WICHITA WATER WALK

THE CITY OF WICHITA
SEDGWICK COUNTY. KANSAS
MICHAEL E. LINDEBAK, CITY ENGINEER

WICHITA WATER WALK
WICHITA, KANSAS
FOR THE
CITY OF WICHITA

COVER SHEET

A / LS-5 PORTE-COCHERE ENLARGEMENT
SCALE: 1/4" = 1'

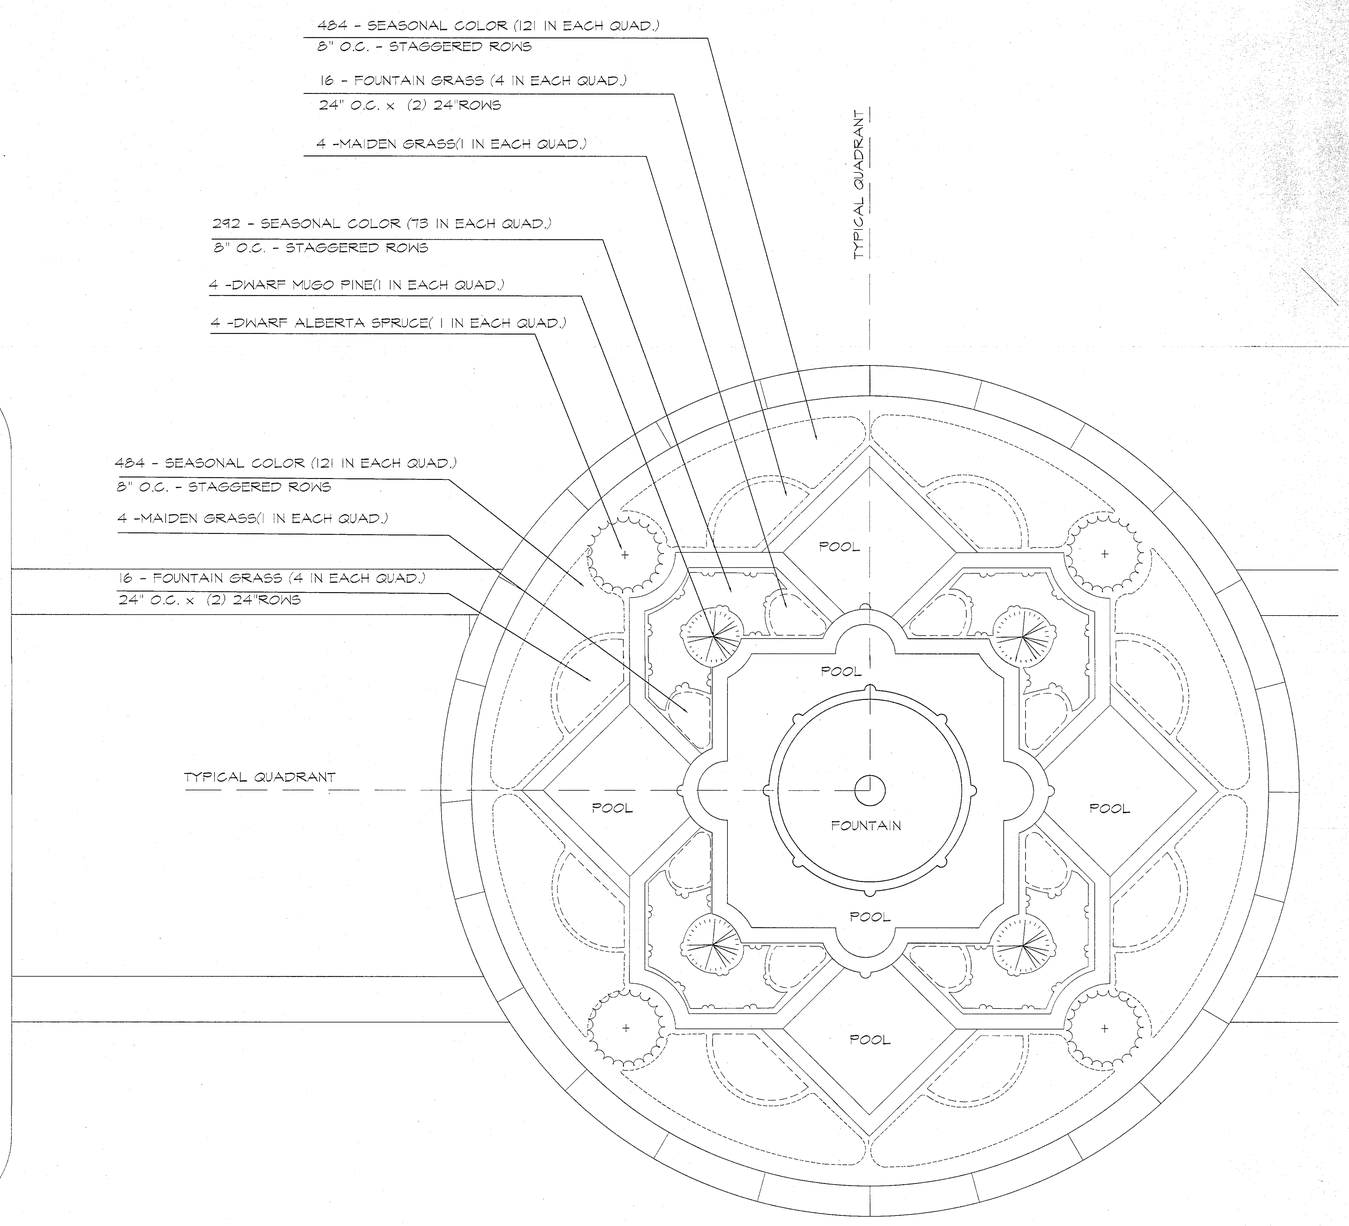
Drawing LS-5: All landscaping in Detail B/LS-5 is a part of ADD ALTERNATE 2.
